KMR.CDD.LyQ.1918.04

NOTICE UNDER SECTION 96 OF ACT III OF 1901.

I beg to inform you that I intend building Stables
on plot No. 46Survey Sheet No. K-5 situate in -Street, Hydrabad Quarter.As required by the rules of the Municipality, I beg to submit herewith a
plan of the same for your approval.

PLAN SHOWING
STABLES TO BE BUILT ON PLOT

PLAN

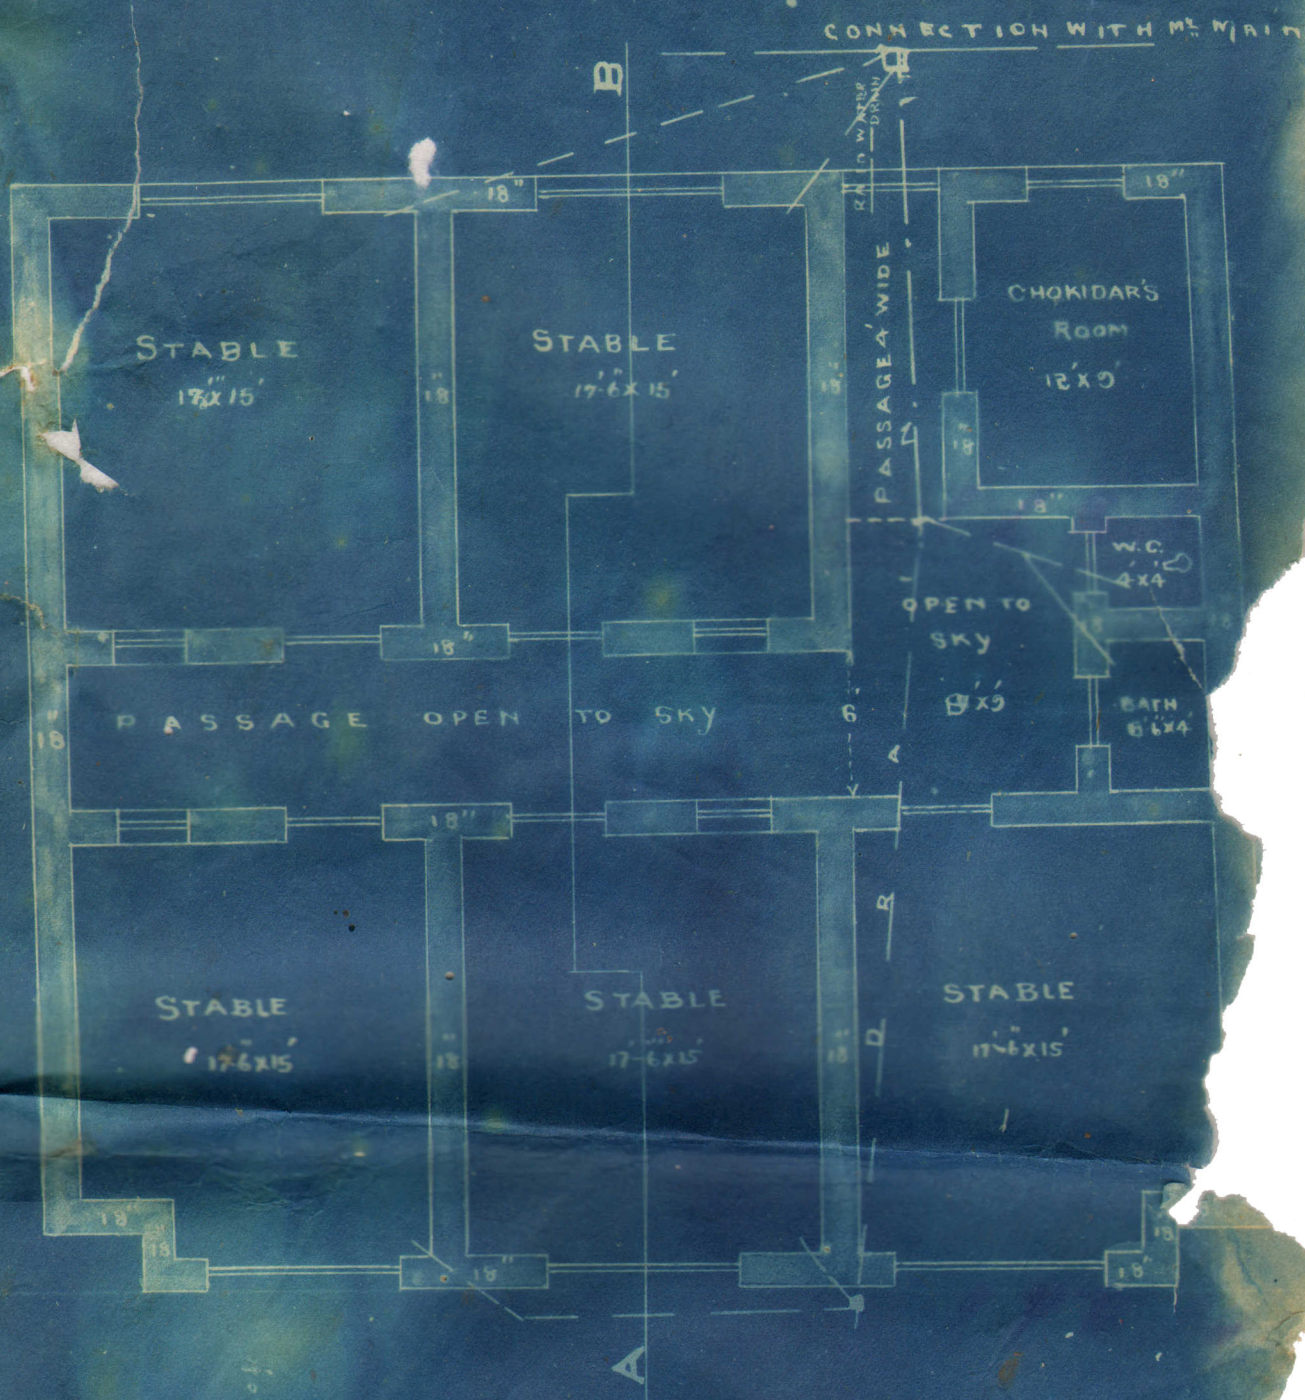
Red Survey is
It is impossible to tell where
the plot is from the plan.
No names are given to the streets
The width of the street marked in all corners
he checked & marked on the plan.
V. 30/1/19

The plan as submitted is marked stables
but is not designed for stables. If it is the
intention of the owner to keep horses & carts
he must have stables for the horses & coach
houses for the carts. The passage into the
Compound is too narrow, it should be 8'-0"
wide.

With reference to his application dated 24th ultimo with plan for the proposed stables on plot No. 46, K-5 Lyari Quarter Mr. Jeramdas Mangoomal is informed that the plan as submitted is marked stables but is not designed for stables. If it is his intention to keep horses and gharrys, he must show stables for the horses and coach houses for the gharrys. The passage into the compound is too narrow, it should be 8'-0" wide.

The plan is returned herewith for amendment.
